Technical Service Bulletin: TSB210001

New Thermocouple Exhaust Gas Temperature Sensor (EGTS) Introduction

- QSK50 CM2150 MCRS
- QSK50 CM2150 K107

Figure 1, EGTS Damage Examples.

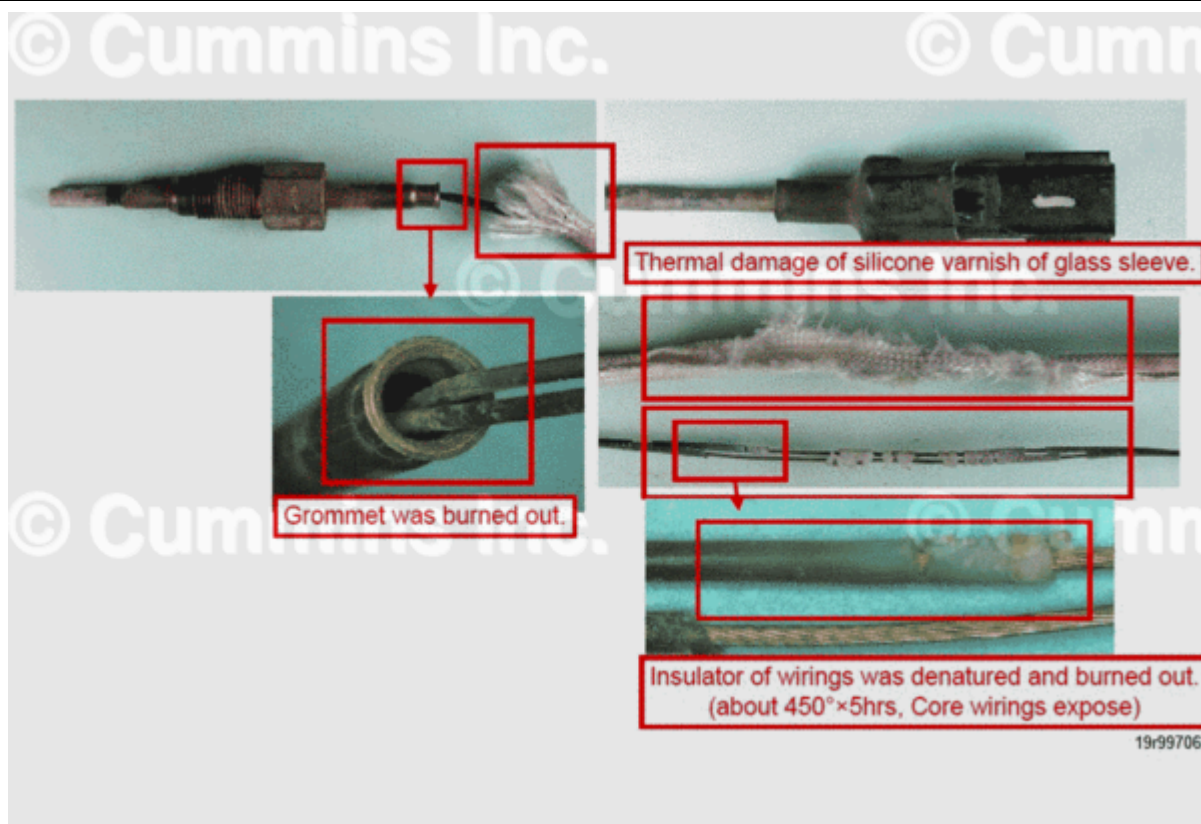
- The exhaust gas temperature sensor (EGTS) cable tensile strength capability has been exceeded due to the sensor cabling being exposed to high heat causing cable fracture.
- Proximity of the EGTS to exhaust manifolds which have radiant temperature of greater than 400°C [752°F] causes the EGTS transition point (from the solid to the braid) to overheat and malfunction.

- New longer body thermocouple EGTS, which have higher working temperature capability around the exhaust manifold area, have been released. Service Parts Availability section below for part numbers.
- Existing thermistor EGTS are **not** compatible with thermocouple EGTS. See Part Compatibility section below.

Figure 3, New EGTS Routing.

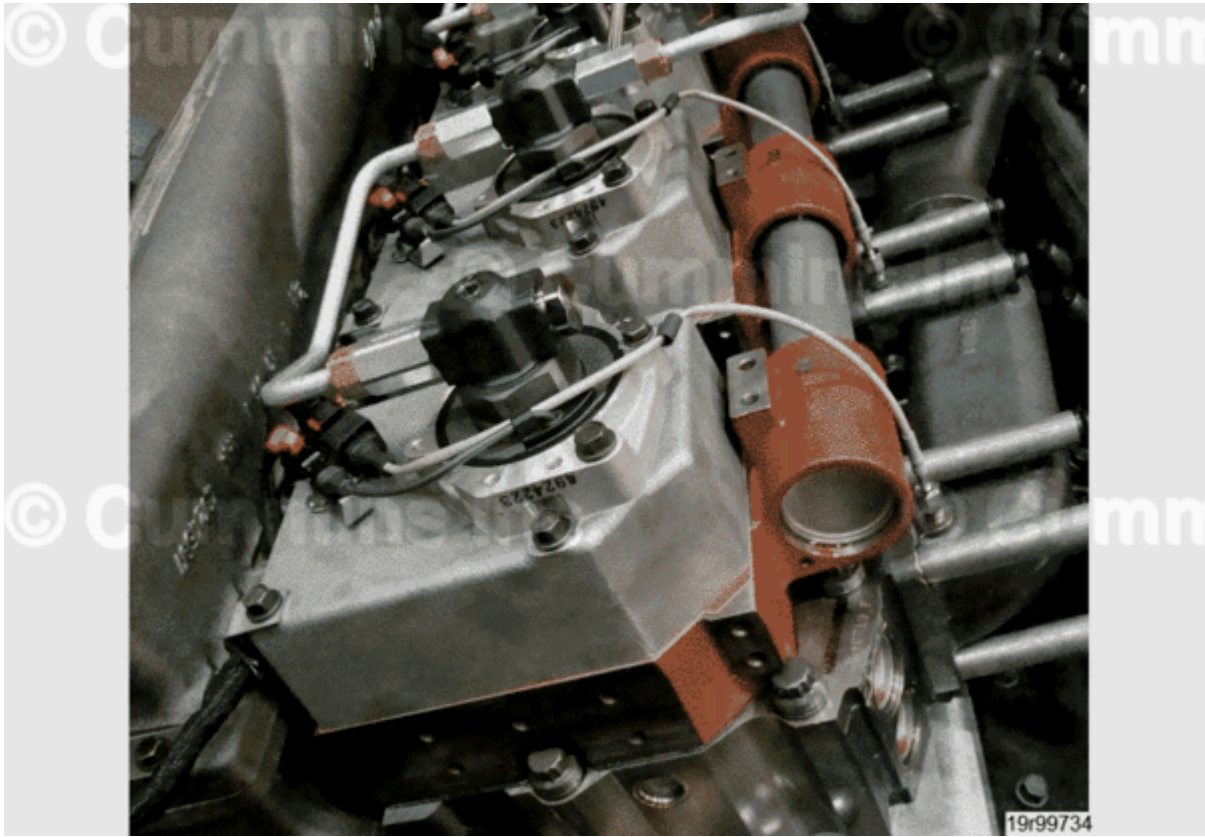
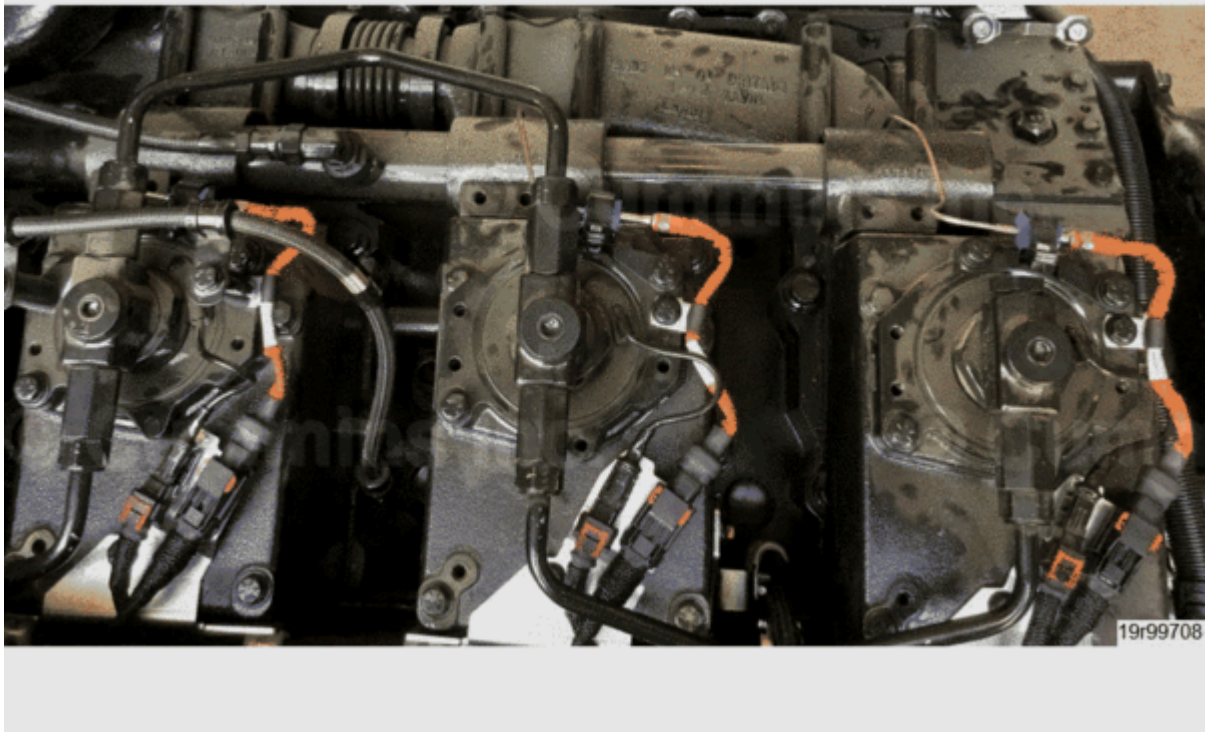
Four new thermocouple EGTS are required to properly route the sensors from the exhaust manifold and avoid interfering with other components such as water and exhaust manifolds, turbochargers, etc. at the top of engines. The inconnel of the thermocouple EGTS has a higher temperature rating is much longer than the thermistor EGTS. The thermocouple EGTS have dark orange cables.

Figure 4, EGTS Part Number Locations by Cylinder.

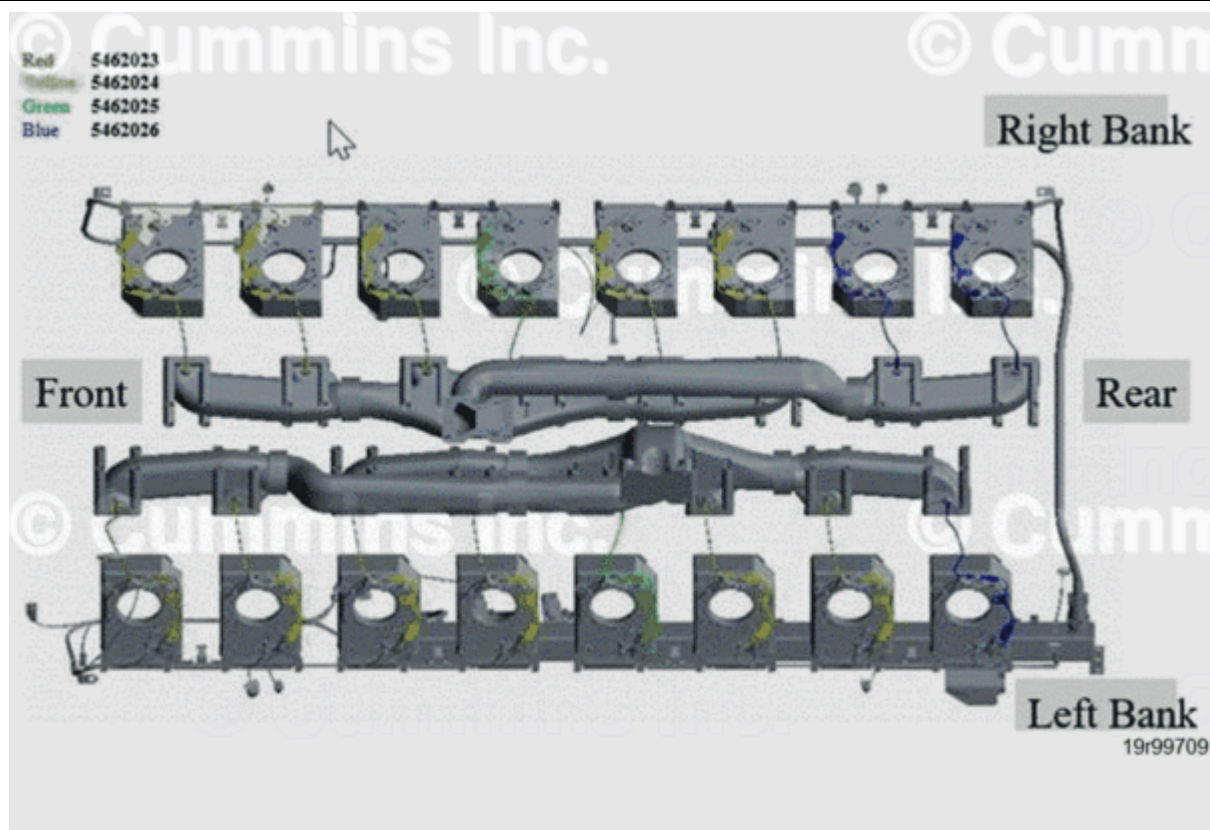
See Table 1 below to identify what EGTS part number is compatible with a cylinder location.

Figure 5, EGTS Converter Box.

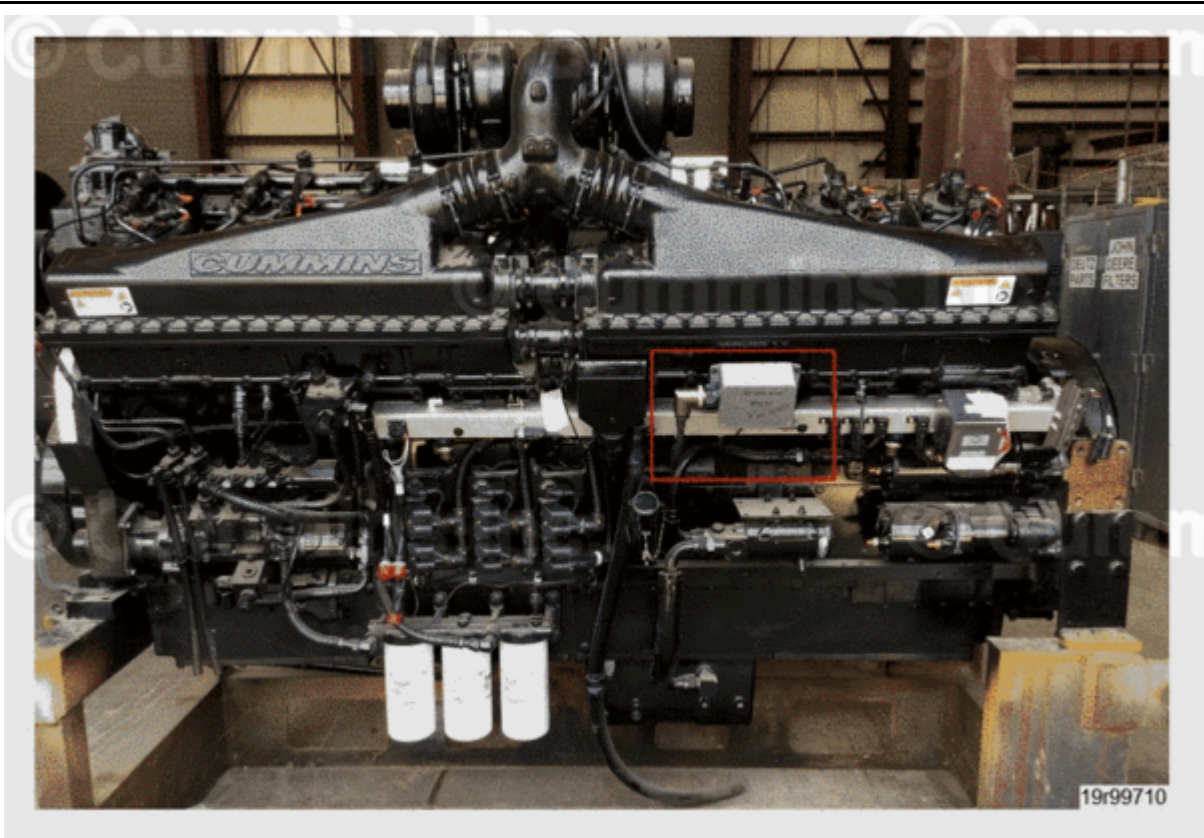
The main engine wiring harnesses now have an additional converter box connector breakout. This can be found on both the Left Bank (LB) and Right Bank (RB) main engine wiring harnesses.

Figure 8, EGTS Converter Box.

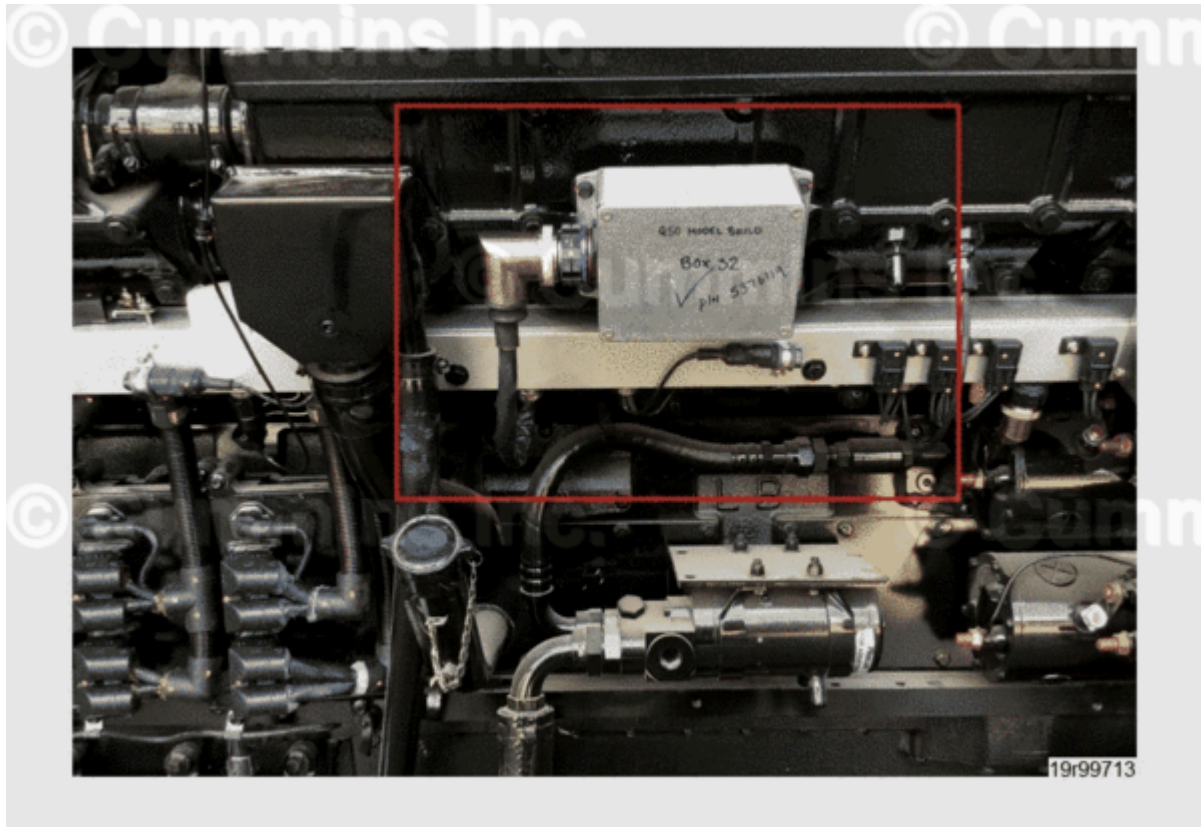
Two converter boxes are required to house and protect the internal signal conversion modules. The internal signal conversion modules process the thermocouple EGTS's signals for the engine's ECMs. Both LB and RB converter boxes are mounted on the air intake manifold of the engine.
